Annexure 6: Evidence of Comments Received

COMMENT ON THE REVISED DRAFT BASIC ASSESSMENT FOR THE PROPOSED RESIDENTIAL DEVELOPMENT ON PORTION 91 OF THE FARM MATJES FONTEIN NO. 304, KEURBOOMSTRAND

COMMENTS ON THE REVISED BASIC ASSESSMENT REPORT PROPOSED RESIDENTIAL DEVELOPMENT ON PORTION 91 OF FARM MATJESFONTEIN 304, KEURBOOMSTRAND, PLETTENBERG BAY, WESTERN CAPE PROVINCE

COMMENT ON THE REVISED BASIC ASSESSMENT REPORT FOR THE PROPOSED RESIDENTIAL DEVELOPMENT: MATJESFONTEIN 304, PORTION 91(PORCION OF PORTION 14), DIVISION PLETTENBERG BAY

Figure 1: Illustrating the Preferred Site Development Plan in relation to the biodiversity attributes.

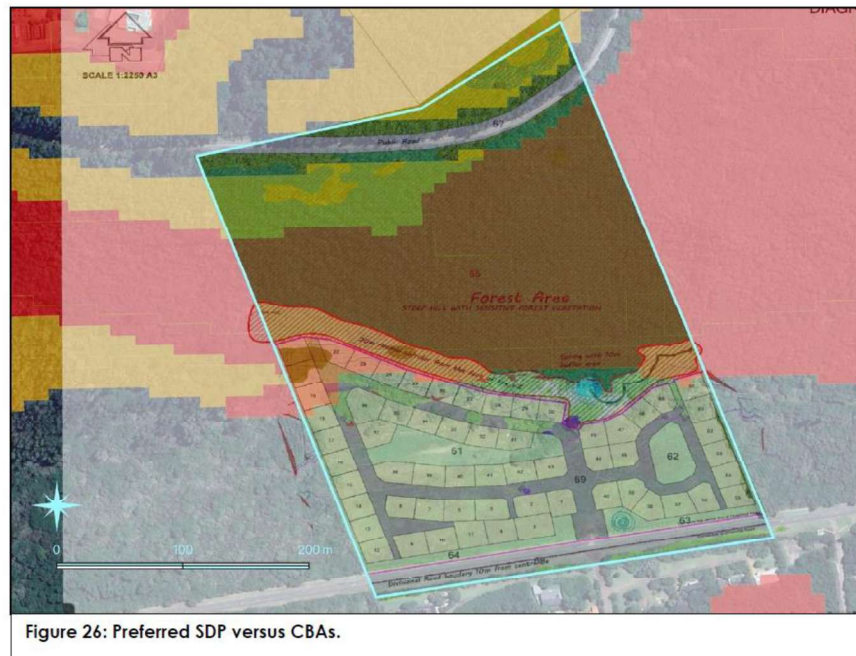
4. CapeNature does not support the development where it overlaps (Fig. 1) with areas which has been indicated as medium sensitivity, CBA, "secondary vegetation" situated between the forests and the flat part of the site, and the "fynbos with invaded aliens".

Fig.10: Topographical cross-sectional plans A to A' as per Fig.9 . Beacon Survey June 2024 and VPM Survey 2023.

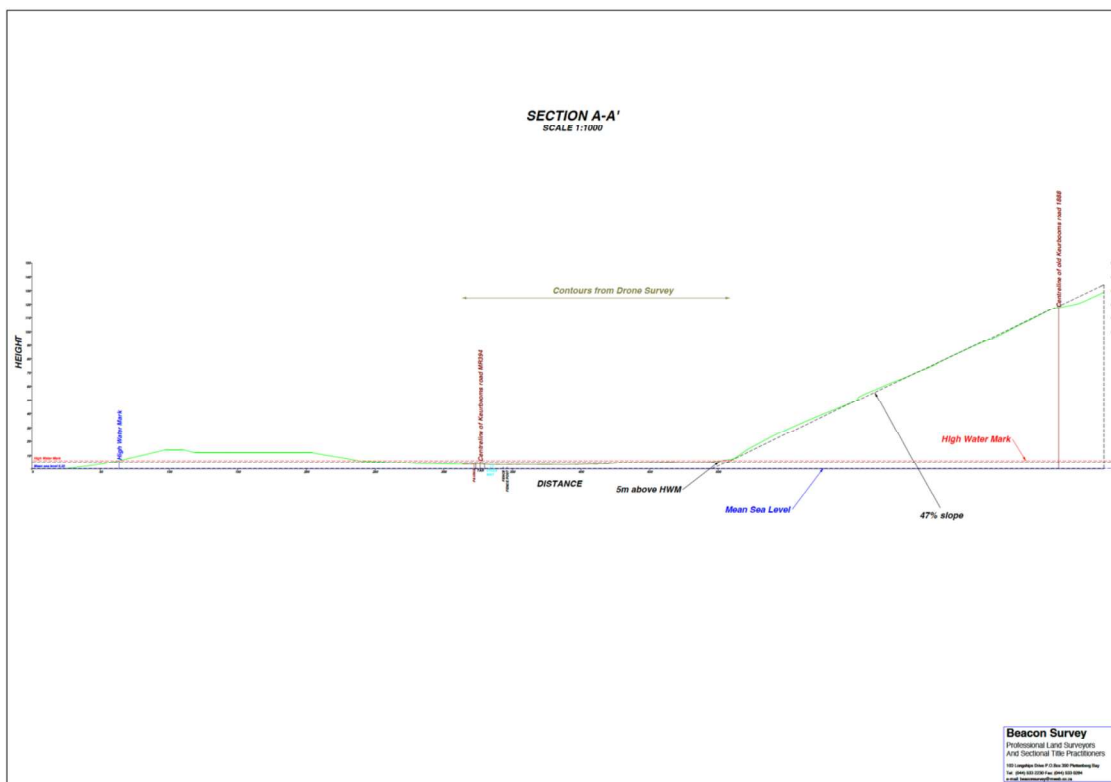
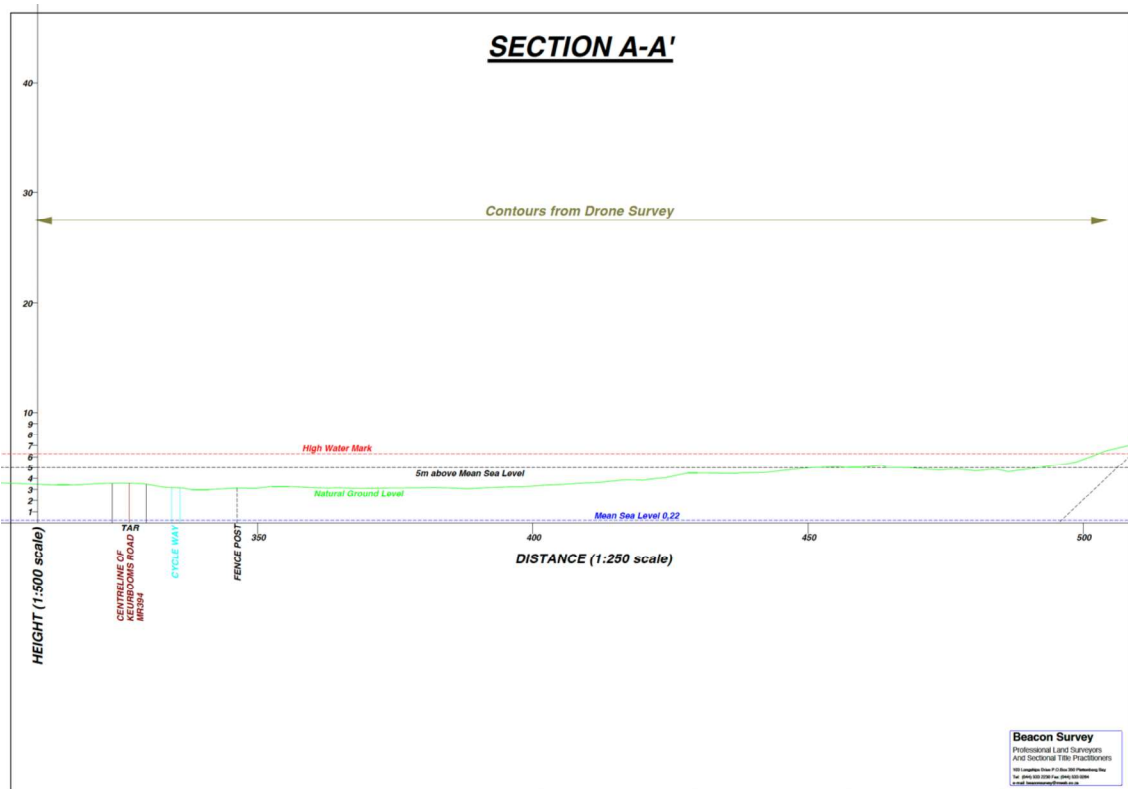
- 1) Part of the developed Portion 14/304, Milkwood Glen site (seaward of Portion 91/304), is less than 5m above mean sea-level.
- 2) All of the PO394 road and the road reserves either side, are less than 4m above mean sea-level.
- 3) Almost all of the southern flat portion of Portion 91/304, is less than 4m above mean sea-level.

All of the above mentioned sites ie 1), 2) and 3), are situated in the Keurbooms-Bitou Estuarine Functional Zone, a flood plain, which is less than 5m above mean sea-level.

Fig.12: Keurbooms Estuary: Estuarine Management Plan showing 1 in 50 and 1 in 100 flood lines.

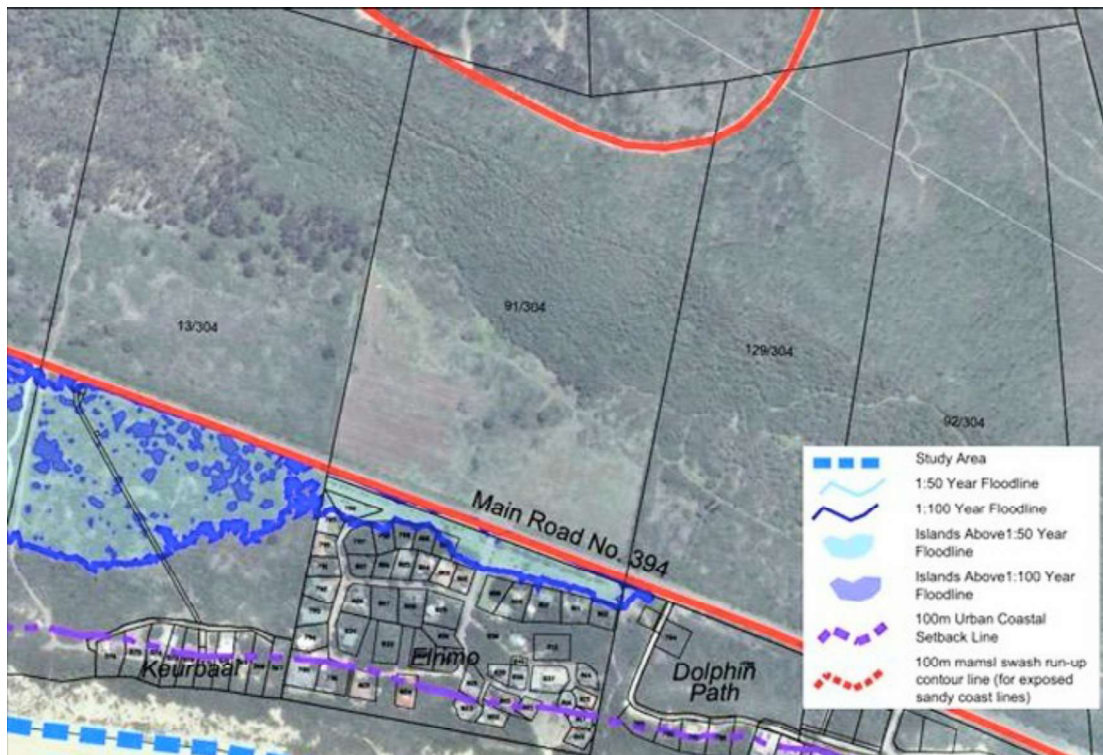
I would strongly agree that the 1 in 100 year flood line, should therefore be reviewed, as per the recommendations of the Garden Route District Climate Change Adaptation Response Implementation Plan (2024).

This plan recommends NO NEW DEVELOPMENTS on land within the risk area, defined as within the 1 in 100 year flood line, or less than 5m above mean sea-level. ie NO NEW DEVELOPMENTS ON LAND LESS THAN 5 METRES ABOVE MEAN SEA LEVEL OR WITHIN THE 1 IN 100 YEAR FLOOD LINE, WHICH EVER IS THE GREATEST.

Figure 2 Cross-section through part of the proposed development site (south is on the left, north on the right).

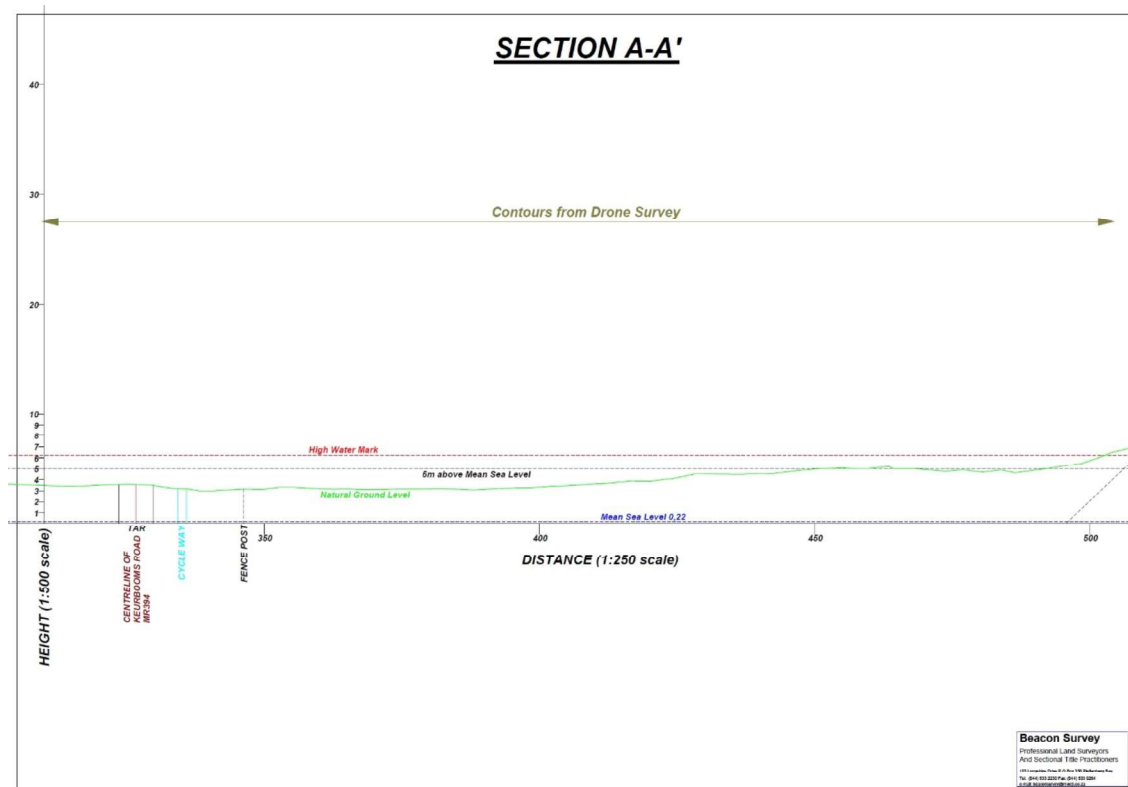
The cross-section data suggests that almost all parts of the development will be below 5m above mean sea level (the black dashed line in Figure 2). There seems to be little doubt that the site does play a role in providing some flood storage, as well as the fact that the site is highly likely to be flooded during heavy and prolonged rainfall events.

8.6.8	With regard to the 1 in 100 year floodline Dr Hughes presents Figure 2 which indicates that at Portion 91 the road does not appear to be above the surrounding ground levels and it is therefore possible that the extent of the floodline could	See items 8.4 and 8.5.3 above
